**SEWAGE COLLECTION SYSTEM INSPECTION FORM
City of Alameda, CA**

Inspection Date: **April 2 – 3, 2009**

Alameda Photo 5 - Catalina pump station

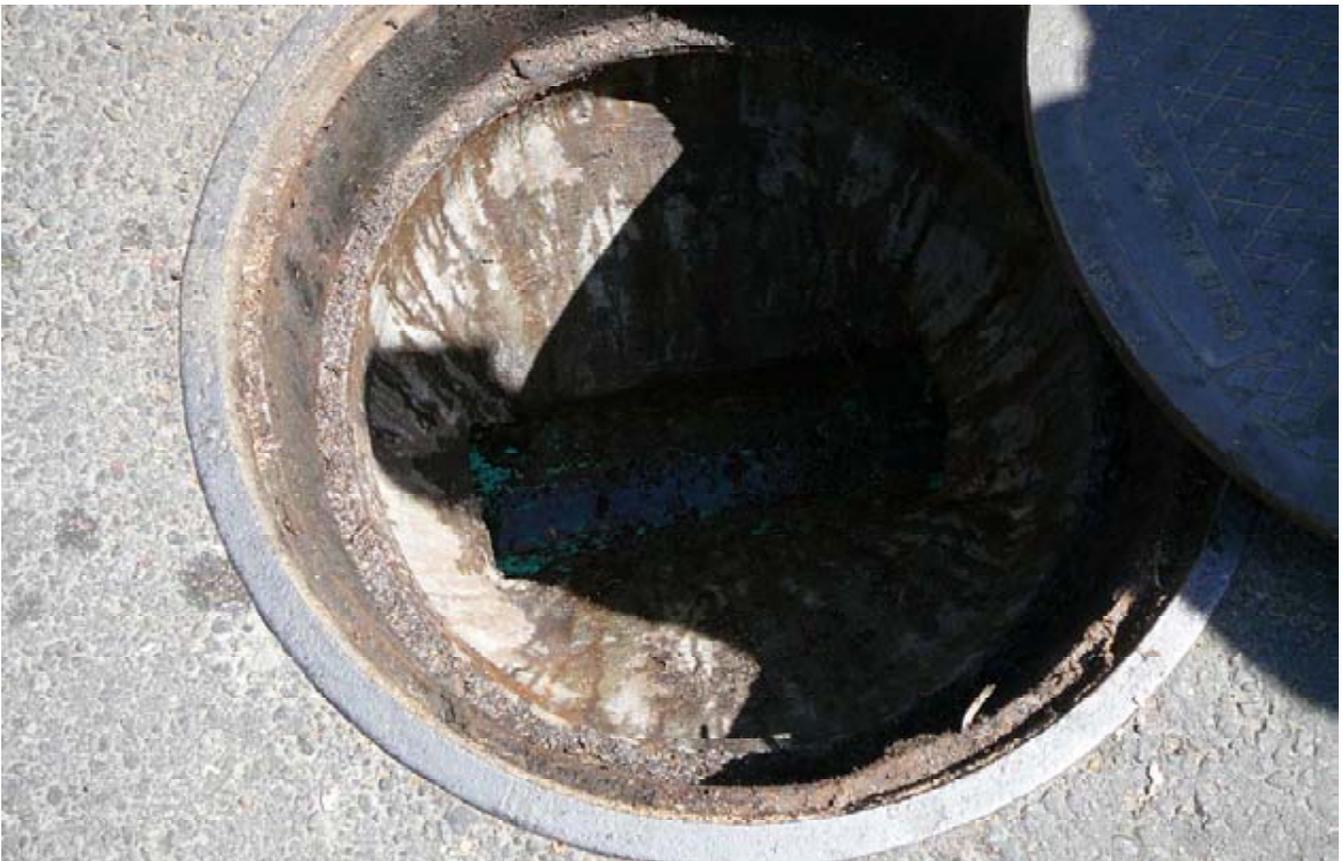
- Catalina (Photos 5 and 6) – located next to a lagoon. This station is not fenced. SCADA is present. A contractor cleans the wet well about every two years.

Alameda Photo 10 - Spill site at Alameda Federal Center - Second manhole showing pipe fix

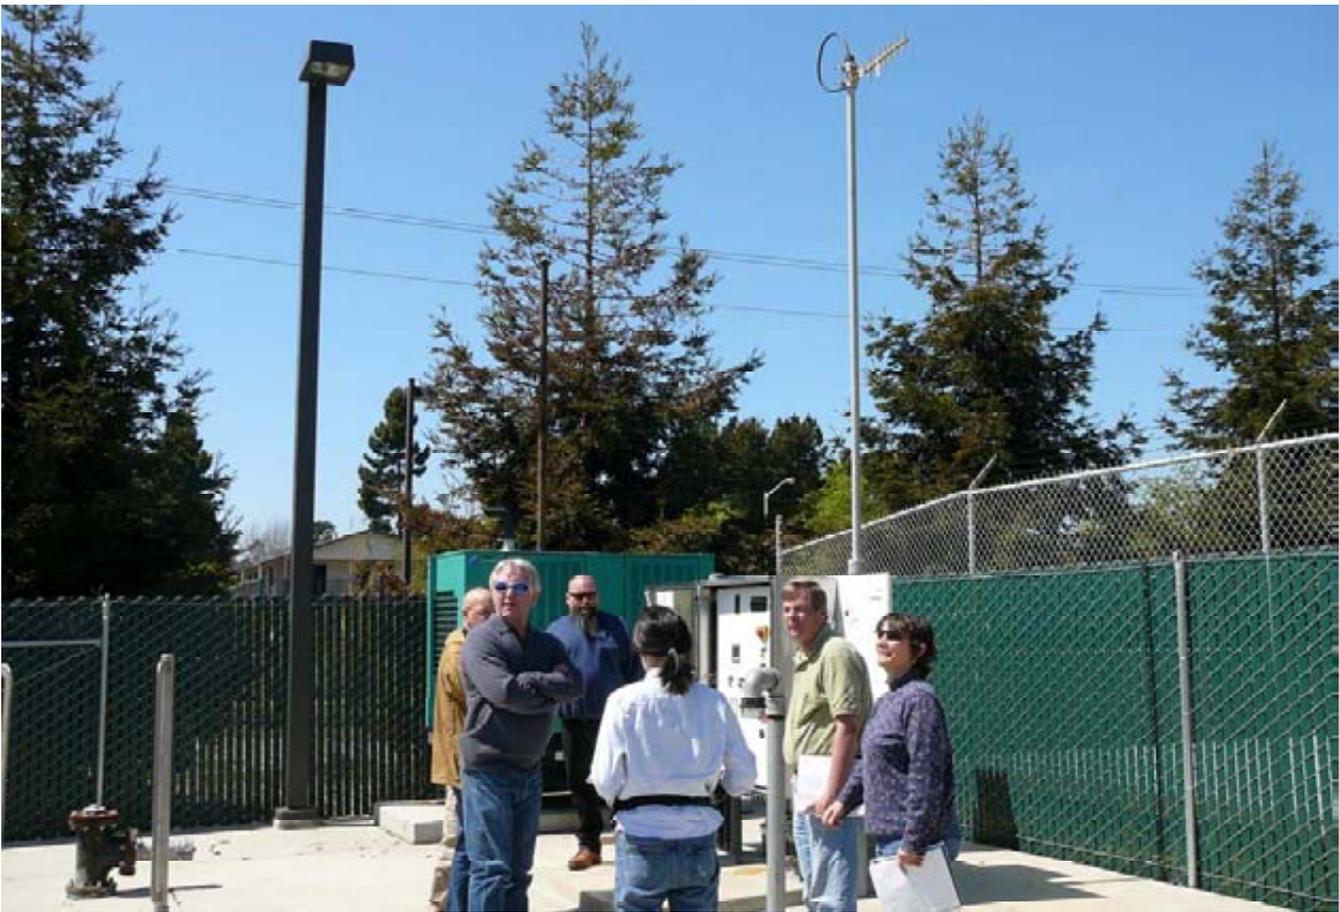
- 8th and Portola (Photo 7) – located next to a park and children's play area. This is the largest pump station. Only the generator is fenced. SCADA is present. The incoming gravity main failed at this location (date unknown). City staff stated that the main failure did not cause a spill. However, a spill did occur due to an operator error when vactoring out the wet well during the main failure. The City did not report this spill because a contractor was operating the vactor.
